ZION NUCLEAR POWER STATION, UNIT 1

AMENDMENT TO FACILITY OPERATING LICENSE

ZION NUCLEAR POWER STATION, UNIT 2

ATTACHMENT TO LICENSE AMENDMENTS

Figure 3.2-9 Hot Channel Factor Normalized
Operating Envelope for Units 1 and 2

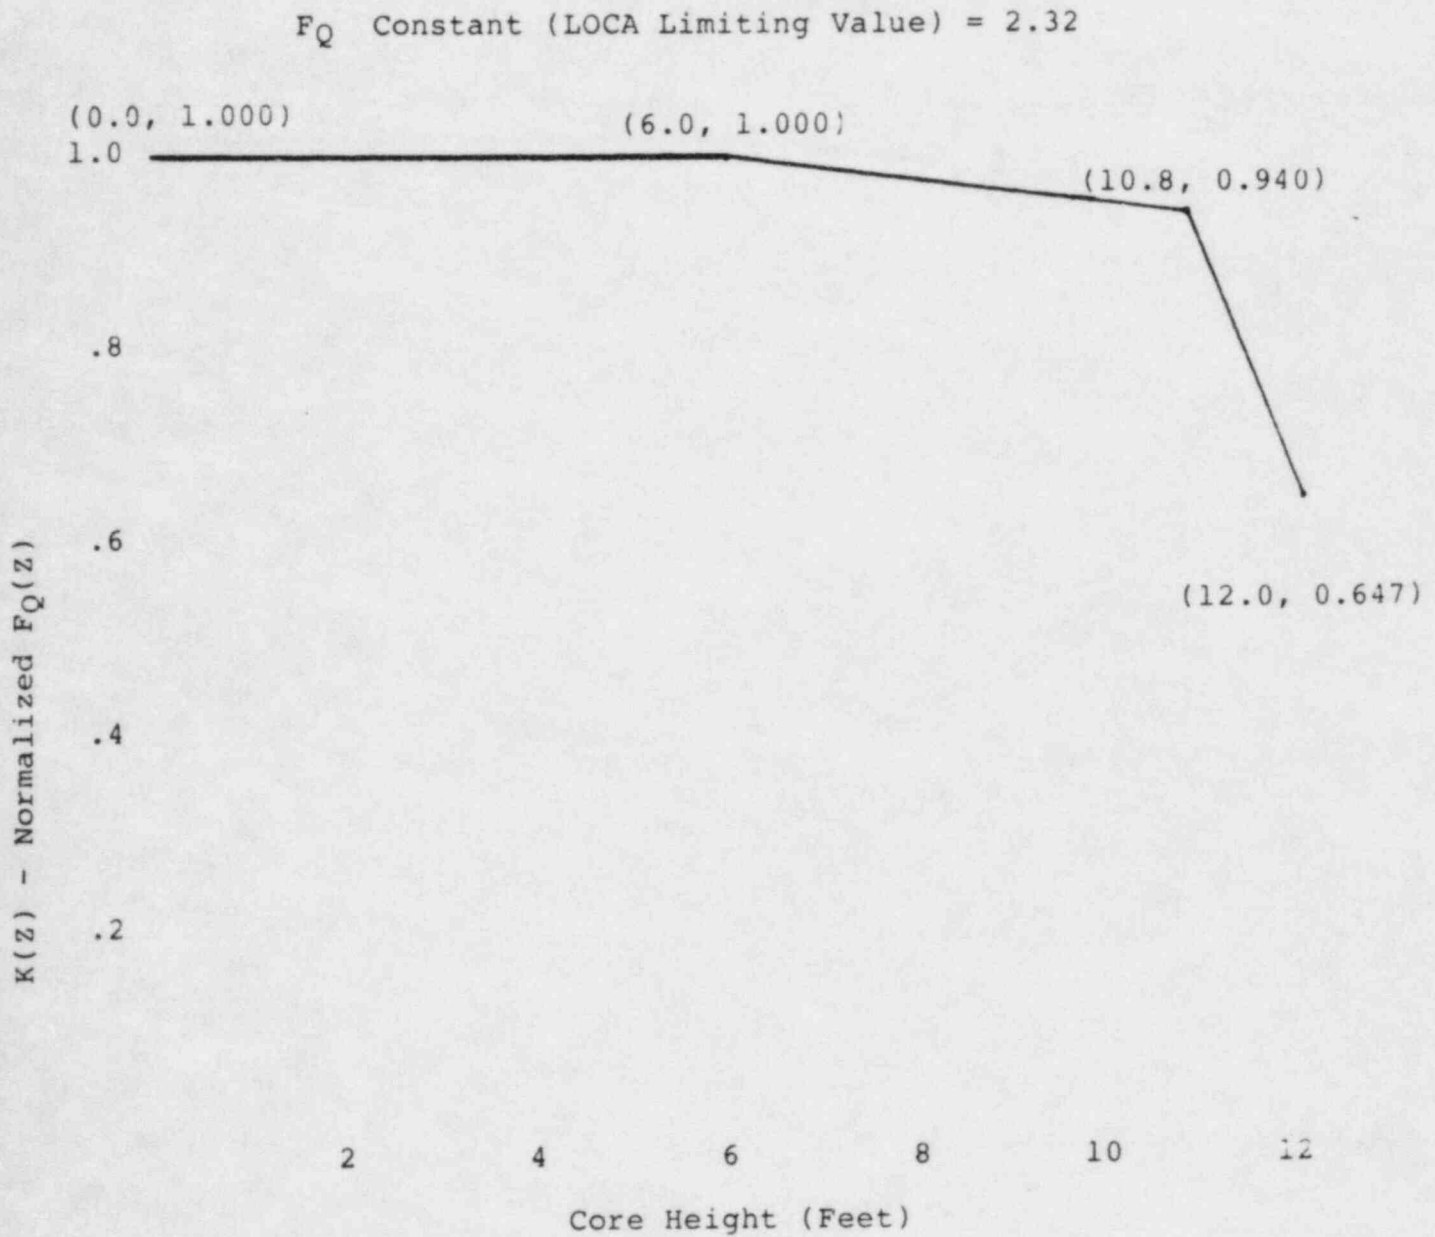
LIMITING CONDITION FOR OPERATION	SURVEILLANCE REQUIREMENT
<p>3.2.2 Power Distribution Limits</p> <p>A. Hot Channel Factor Limits*</p> <p>1.1 At all times, except during physics tests at $\leq 75\%$ rated power**, the hot channel factors defined in the bases must meet the following limits:</p> <p><u>Units 1 and 2</u> $F_Q(Z) \leq [F_Q(Z)]_L = 2.32/P \times K(Z)$, for $P > 0.5$ $4.64 \times K(Z)$, for $P \leq 0.5$ $2.32 = F_Q$ constant (LOCA limiting value); $K(Z)$ = factor from Figure 3.2-9 selected at the core elevation, Z, of the measured F_Q;</p> <p>$[F_Q(Z)]_L = F_Q(Z)$ limit;</p> <p><u>Units 1 & 2</u> (For 4-loop operation above 2% thermal power)</p> <p>and $F_{NH} \leq 1.55 [1 + 0.3 (1 - P)]$ for $0.02 < P \leq 1.00$</p> <p>P = fraction of rated power at which the core operated during F_Q and F_{NH} measurement;</p> <p>* The hot channel factors above are defined for a period not to exceed the predicted minimum time to collapse exposure levels for each fuel region as referenced in the bases.</p> <p>** During Physics tests which may exceed these hot channel factor limits, the reactor may be in this condition for a period of time not to exceed eight hours continuously.</p>	<p>4.2.2 Power Distribution</p> <p>A. Hot Channel Factor Limits</p> <p>1.1 Following initial core loading and at a minimum of regular effective full power monthly intervals thereafter, power distribution maps, using the Movable Detector System, shall be made to confirm that the hot channel factor limits of this specification are satisfied.</p> <p>Following initial loading and each subsequent reloading, a power distribution map using the Movable Detector System, shall be made to confirm that power distribution limits are met, in the full power configuration before a unit is operated above 75% of rating.</p>
